Rezoning Application: RZ-PD 25-1244

Development Services Department

Introduction Summary:

The applicant is requesting to rezone the property from ASC-1 to Planned Development (PD) to allow for commercial uses.

ZHM HEARING DATE: BOCC LUM MEETING DATE:	November 17, 2025 January 13, 2026	Case Reviewer: Carolanne Peddle
8.0 PROPOSED SITE PLA	N (FULL)

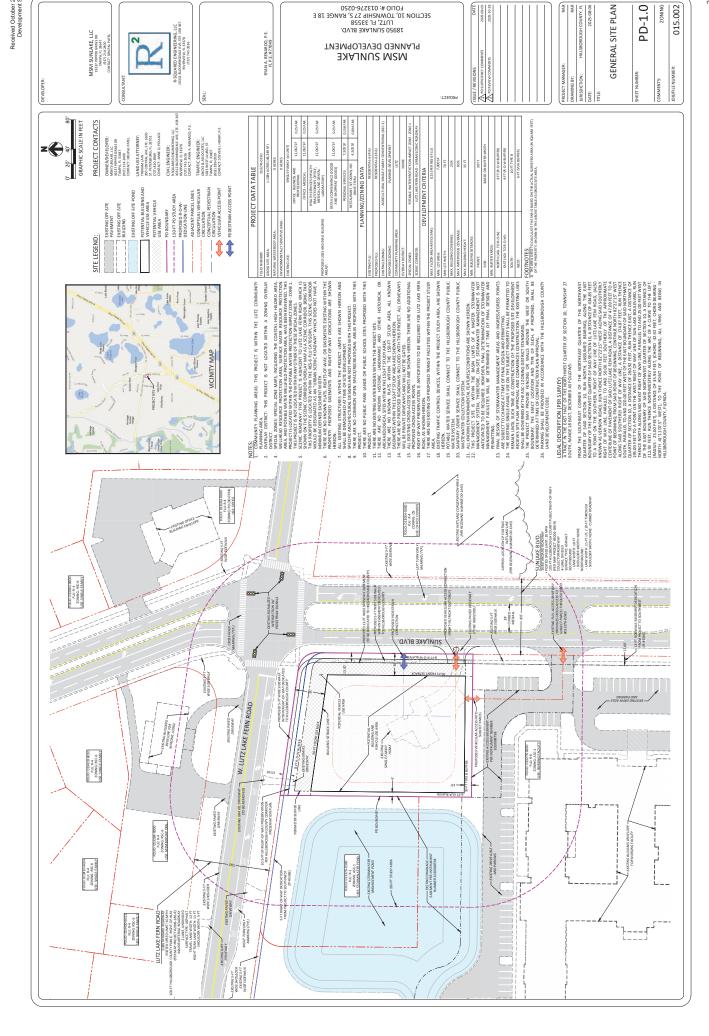
Approval - Approval of the request, subject to the conditions listed below, is based on the general site plan submitted October 28, 2025.

- 3. Buffering and screening shall be provided as shown on the PD site plan.
- 4. Should the site be located within the Wellhead Resource Protection Area, certain uses may be restricted, prohibited, or require additional permitting when applicable.

- 13. The subject site shall be permitted a right-in/right-out access connection onto Sunlake Blvd. and an additional access connection through the adjacent parcel under Folio No. 13276.0260 along the project's southern boundary.

- 15. Notwithstanding anything herein or shown on the PD site plan to the contrary, bicycle and pedestrian access may be permitted anywhere along PD boundaries.

- 16. Nowthingstanding anything shown in the PD site plan or therein the conditions of approval, the applicant shall provide internal sidewalks connections to the project site arrival point, the primary building entrances, parking, and any other onsite amenities consistent with 06.03.02 of the Land Development Code.

FIGURE 1
ACCESS SPACING

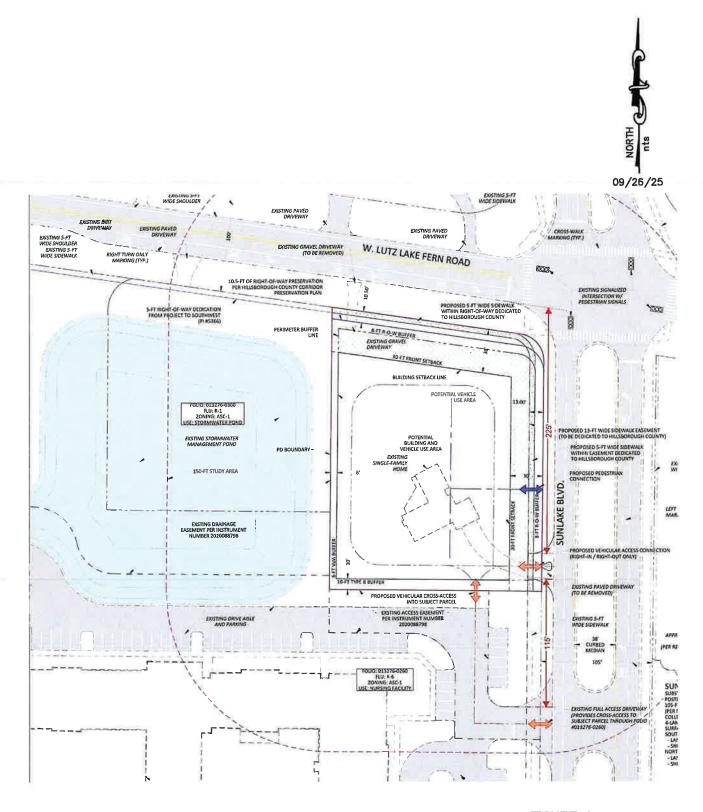
The request is for an Administrative Variance to Section 6.04.07 of the Hillsborough County LDC for the access spacing on Sunlake Boulevard. Based on Section 6.04.07, the access spacing on Sunlake Boulevard is 245 feet. The distance to the driveway is 225 feet from Lutz Lake Fern Road and 115 feet from the access to the Pruitt Health Facility. This is graphically shown in Figure 1.

(a) there is an unreasonable burden on the applicant,

The developer controls limited property frontage along Sunlake Boulevard. Given the property frontage, it is not physically possible to locate the driveway to meet the spacing criteria. Therefore, it is not reasonable or feasible for the project to modify the location of the access to meet the current LDC spacing criteria.

(b) the variance would not be detrimental to the public health, safety and welfare,

The access has been designed and located to maximize the spacing between the access and Lutz Lake Fern Road. The proposed access is limited to right-in/right-out. Therefore, the variance would not be detrimental to the public health, safety and welfare.

The applicant's Engineer of Record (EOR) has submitted a Section 6.04.02.B. Administrative Variance Request (dated and submitted September 29th, 2025) from the Section 6.04.07 LDC requirement governing spacing for the proposed Sunlake Blvd. access. In accordance with this section of the LDC, Sunlake Blvd. has been identified as a Class 5 roadway with a posted speed limit of 45MPH. As such, the minimum connection spacing is 245ft. The applicant is proposing the driveway in a location which is +/- 115ft from the adjacent driveway to the south. As such, the applicant is seeking a variance of 130ft. Based on factors presented in the Administrative Variance Request, the County Engineer found the request approvable on November 7th, 2025.

If this rezoning is approved by the BOCC, the County Engineer will approve the above referenced Administrative Variance Request.
